# SERVICE BULLETIN

SAFETY RECALL 0802 - FUEL CELL ASSEMBLY

Figure 1. Fuel Cell

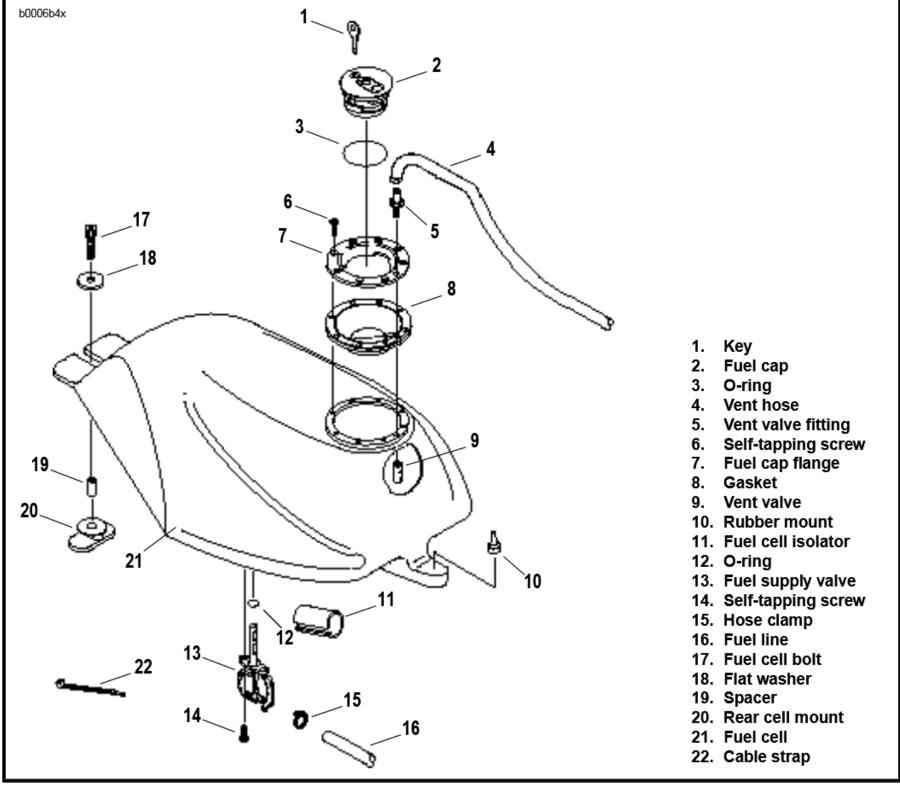
The Buell Motorcycle Company has determined that there is a safety related defect in the fuel cell assembly of certain 1995 S2-Thunderbolt motorcycles shipped from Buell through May 11, 1995. In some cases, minor gasoline seepage may occur at the mold parting line or at the area where the fuel supply valve attaches to the fuel cell.

As a precautionary measure, Buell Motorcycle Company has elected to initiate a voluntary safety recall campaign in the interest of motor vehicle safety. A letter will be sent to registered owners of all affected vehicles requesting that they bring their motorcycle to their Buell dealer. The fuel cell will be removed from the vehicle and returned to Buell Motorcycle Company for inspection. A tested, structurally secure fuel cell will be returned to the dealer for installation on affected vehicles.

See Figure 1. Place fuel cell (21) on frame. Install fuel cell bolt (17) and flat washer (18). Tighten fuel cell bolt to 10-12 ft-lbs (14-16 Nm) torque.

- Install fuel cell cover. Do not damage cover finish upon installation. See Section 2 of the service manual.
- Using the **new** cable strap (22, supplied with the replacement cell), connect overflow vent hose (4) to vent valve fitting (5).
- Carefully inspect fuel line for damage, wear or general deterioration. Replace if necessary.

- Using the **new** hose clamp (15, supplied with replacement cell), connect fuel line (16) to fuel supply valve. Install hose clamp using HOSE CLAMP PLIERS (Part No. HD-41137).
- 6. Install seat. See Section 2 of the service manual.
- 7. Install fuel cap.
- Fill fuel cell with fuel supply valve (13) turned OFF on all customer owned vehicles.
- Open fuel supply valve and carefully inspect for leaks.
   Turn valve OFF after inspection is performed.
